11 December 2019
5809_312_DPIE_ES Submission.docx

RE: Hanson Sancrox Quarry SSD Application No. 7293

The following comments provide the submission on behalf of Expressway Spares with respect to the proposed Hanson Sancrox Quarry expansion SSD No. 7293 documentation as exhibited:

Photo 4: Location of Leak

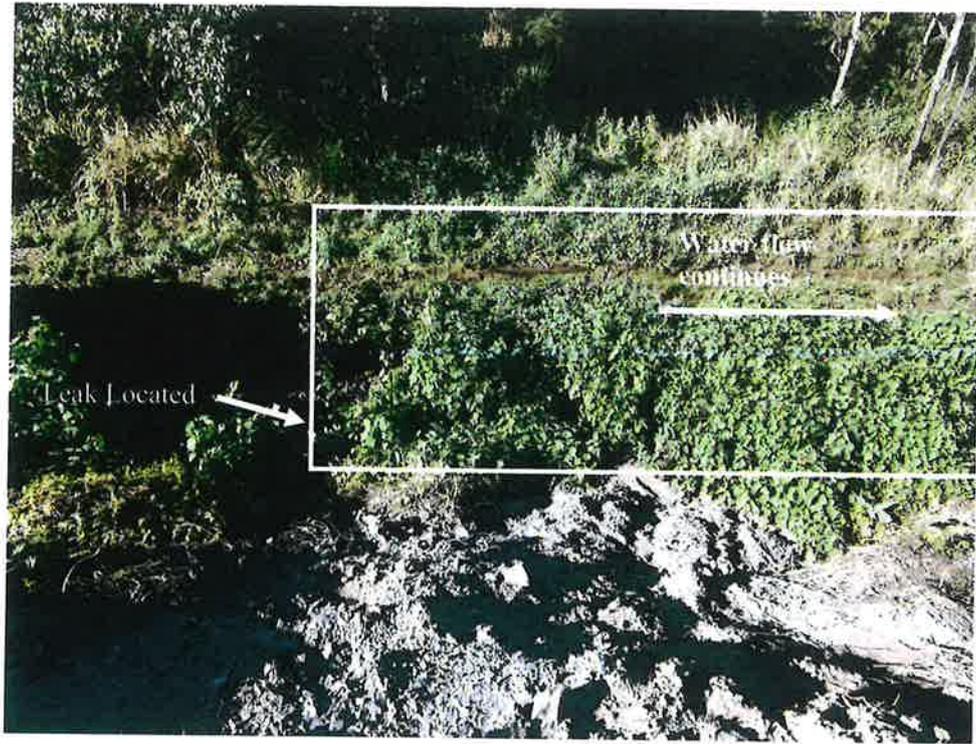
However, on further investigation by myself, after cutting back some of the overgrowth in the 'wet area,' and digging into the ground, water can be seen running out of the ground. The location of this can be seen as indicated by the blue circle on the Site Plan and in Photos 4 & 5. The location of the leak is approximately 1.5m lower than the base of the drain.

Where to now? We have approximately 5 days pumping to empty the sump in the pit (pending further rain). Once this is complete, we will be able to empty the drain and complete the concrete works in this area. When we are confident that no water is able to escape along this section, further investigation will be carried if the leak found today continues.

SECTION DD CH 30 - CH 70

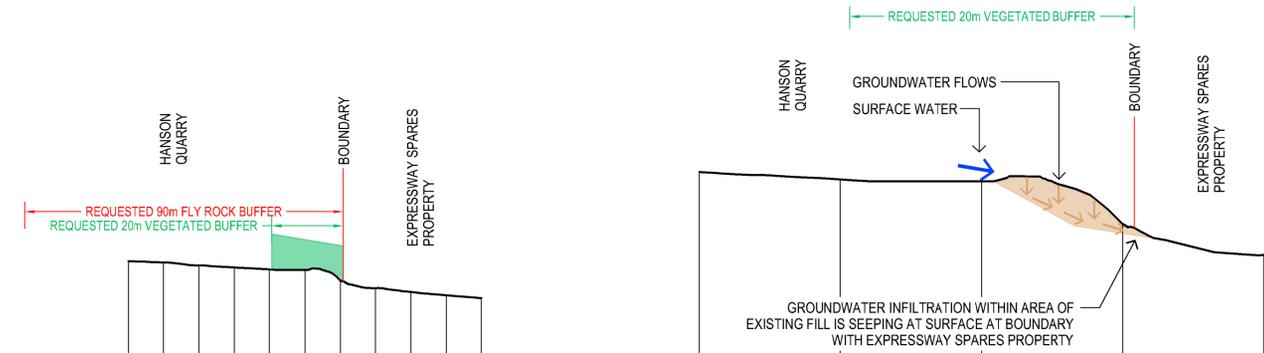
Attachment C contains cross-sections prepared by King & Campbell. Section DD shows the origins of this stormwater drainage issue from within the gravel and loosely filled established sales floor. The ongoing seepage of water from the sales floor has occurred over the lifetime of the quarry.

Connectivity Value - Post Development Site
Connecting Links
(Current linkage widths)

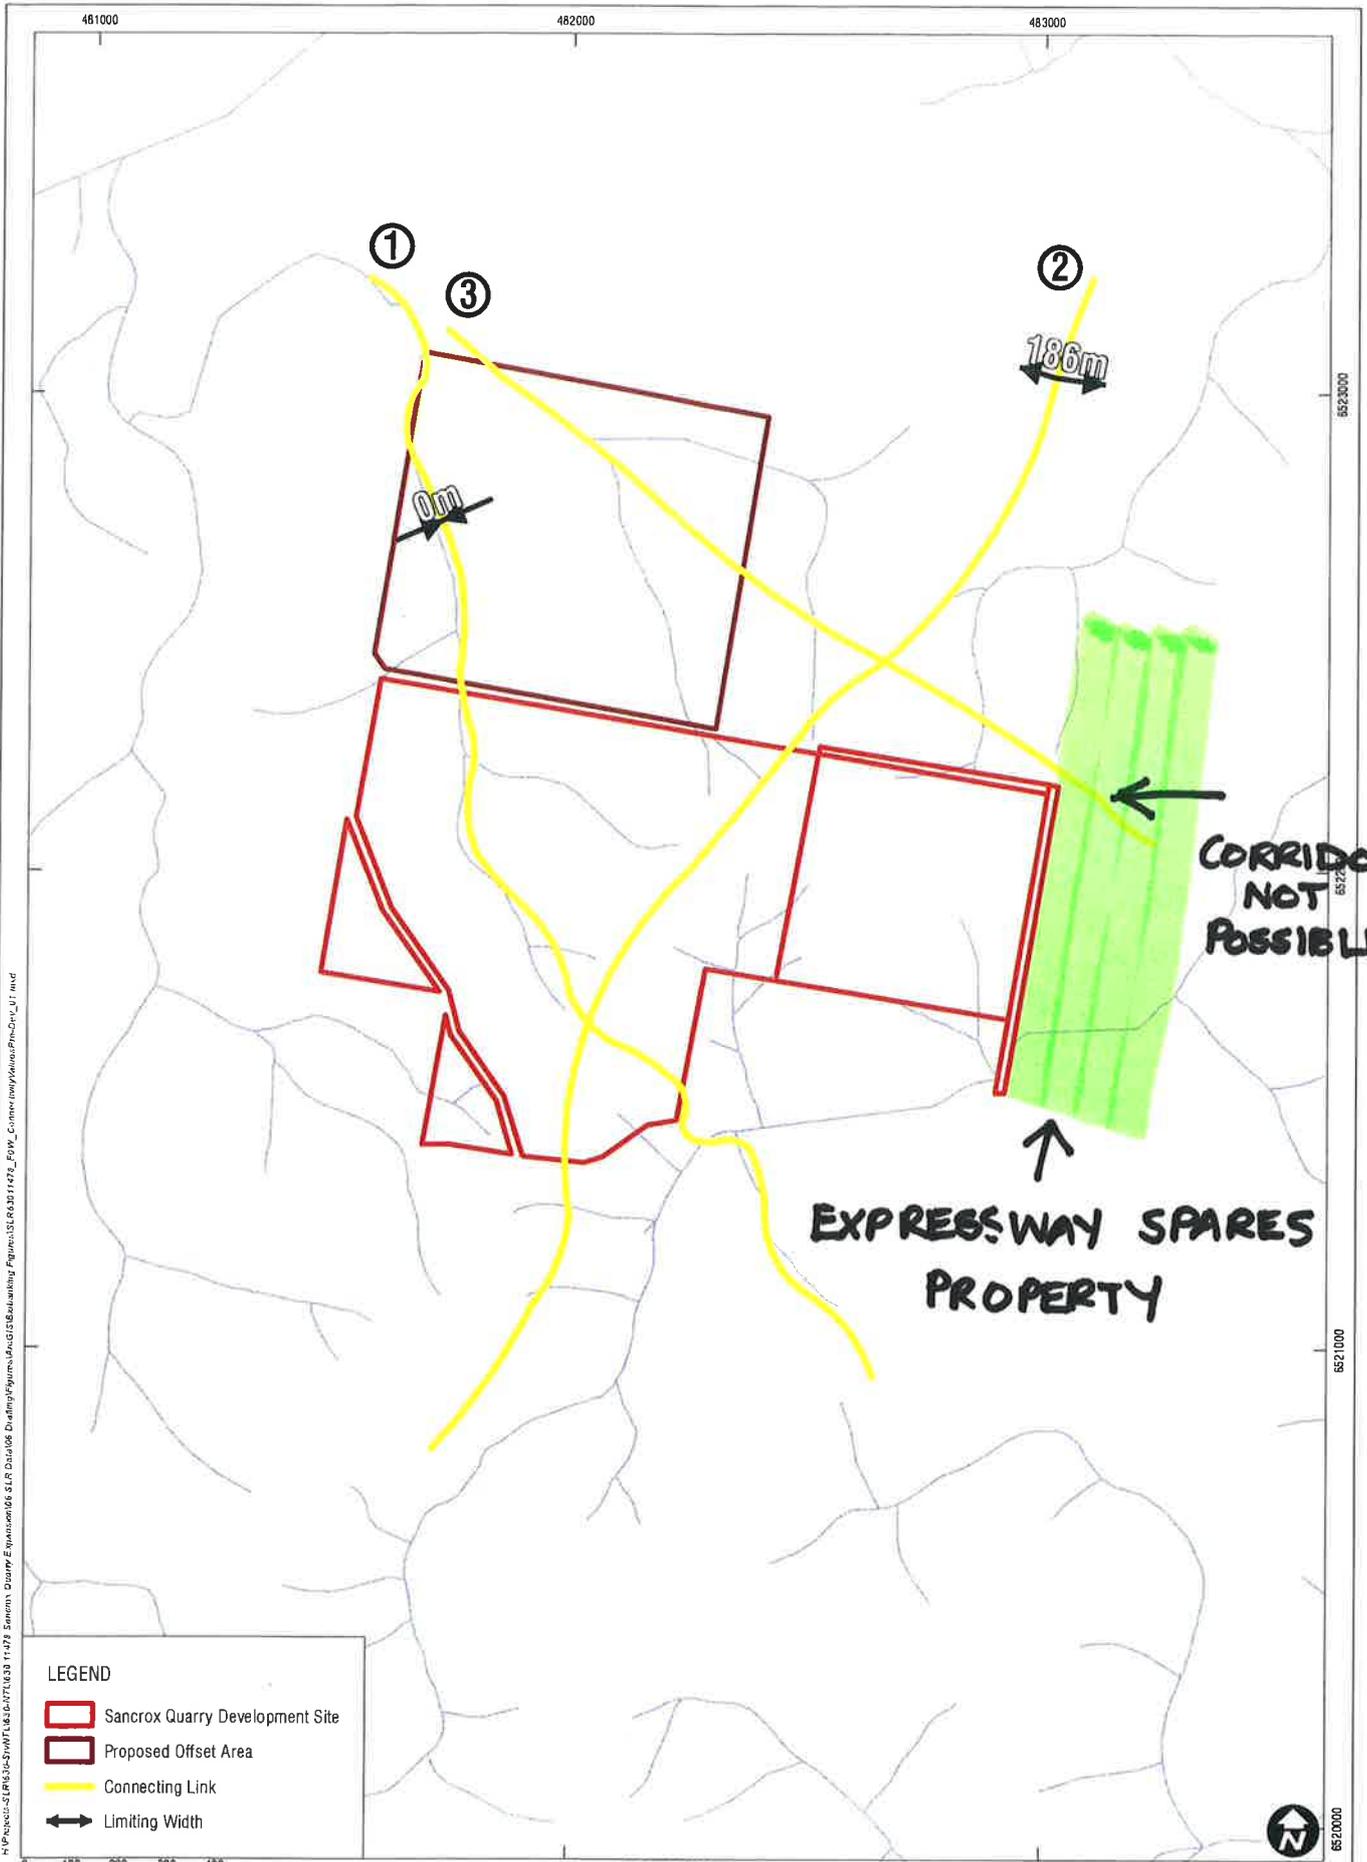
Attachment E includes a copy of the SLR Consultant suggestion regarding a "Post Development Site Connecting Link" of 85.3 metres on Expressway Spares property.

This suggestion fails to understand that the property is in the process of being development for an industrial subdivision and given that lack of understanding of the surrounding properties we query what else is being missed within the SLR work. Mitigation for loss cannot be made up on neighbouring properties, especially one that is zoned general industrial.

DRAWING TITLE:	QUARRY SECTION LOCATIONS - EXPRESSWAY SPARES
PROJECT:	SANCROX ENTERPRISE ZONE - QUARRY INVESTIGATION LOT 353 DP 754434, LOT 2 DP 574308, LOT 1 DP 555095, ORLEANS AVENUE, SANCROX
CLIENT:	EXPRESSWAY SPARES PTY LTD

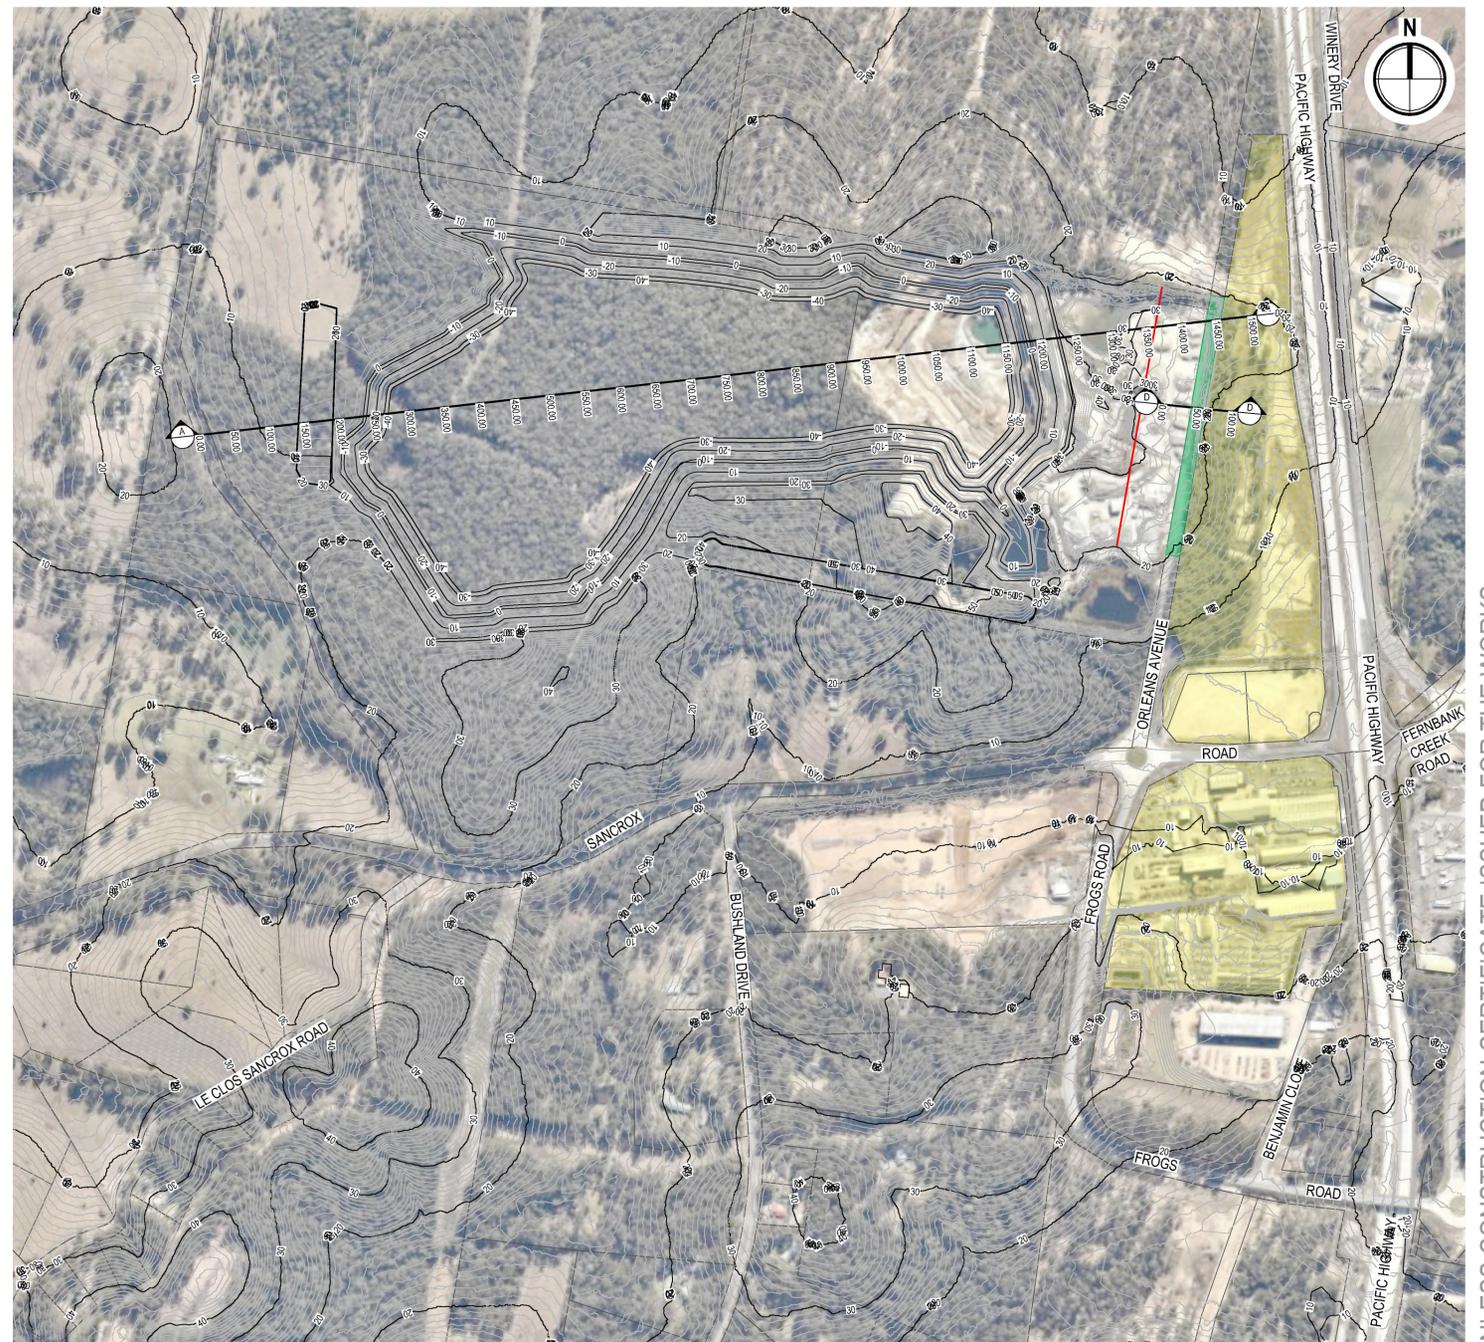
Given the scale of the proposed development and the nature of the crushing and processing equipment, it is submitted that a bund wall be placed along the Eastern boundary adjacent to Expressway Spares property in order to deal with noise issues.

Attachment F contains a plan and cross section of the eastern quarry boundary and shows the Expressway Spares' suggested bund wall location and extent.
